UNITED STATES ENVIRONMENTAL PROTECTION AGENCY

Re: Final Remedial Investigation Report

**FINAL REMEDIAL INVESTIGATION REPORT
FOR THE
NEW YORK CITY SCHOOL CONSTRUCTION AUTHORITY
PILOT STUDY TO
ADDRESS PCB CAULK IN NEW YORK CITY SCHOOL BUILDINGS**

**USEPA CONSENT AGREEMENT AND FINAL ORDER
DOCKET NUMBER: TSCA-02-2010-9201**

Figure 9.12 – 1st Floor Classroom Average Total Airborne PCB Concentrations versus Measured Air Exchange Rates at P.S. 199M

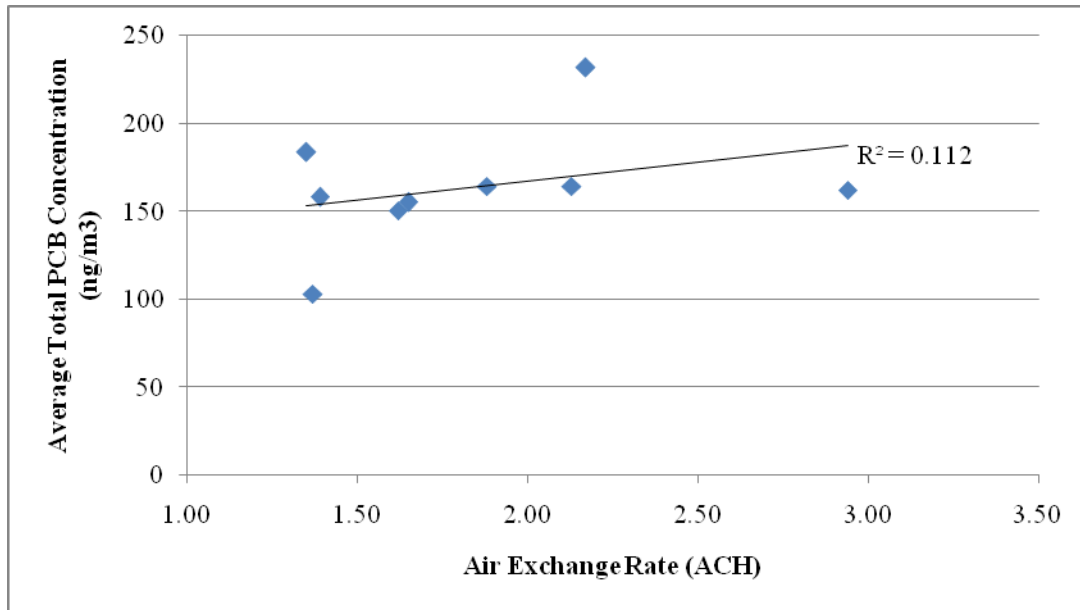
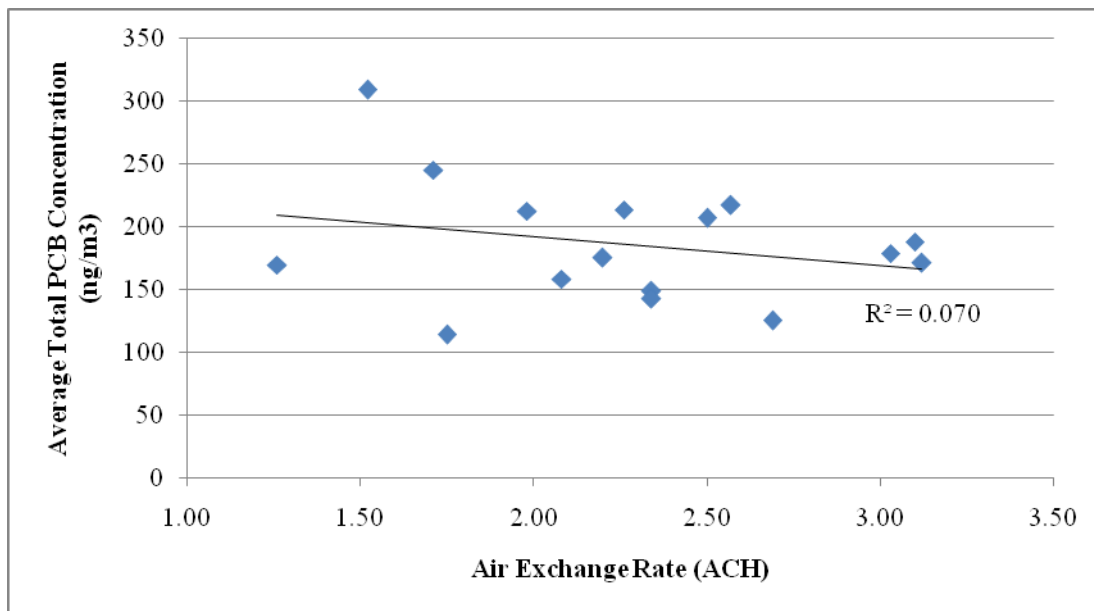
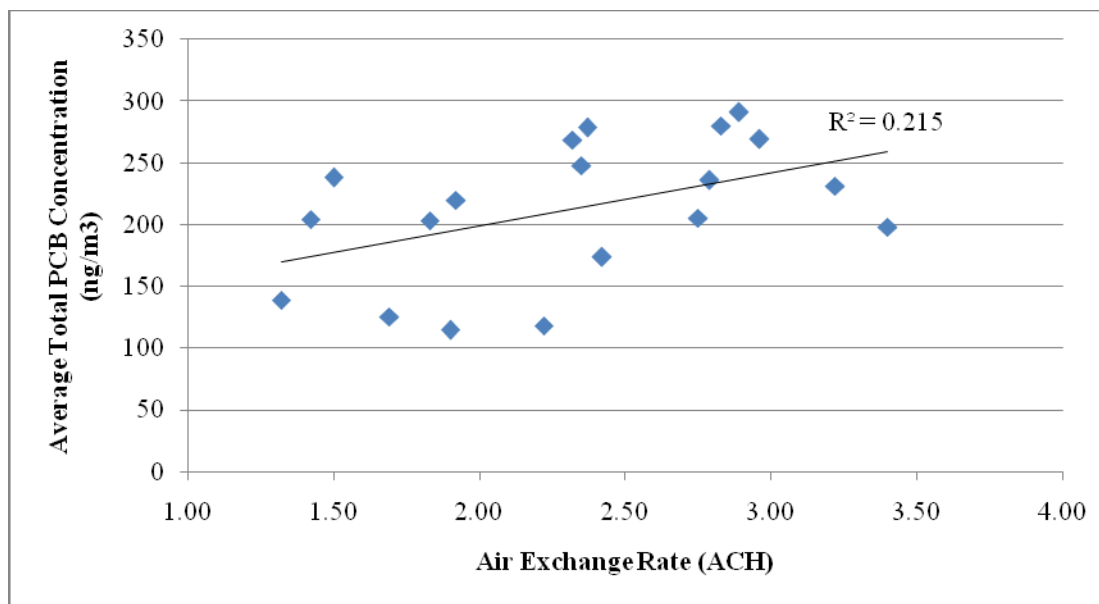
EPA also believes that the preferred remedy should include provisions for improved ventilation. We have seen that air exchange rates within the individual classrooms at P.S. 199M improve substantially when the windows are slightly opened. Improved ventilation is a necessary component of any strategy to address PCBs in the indoor air.
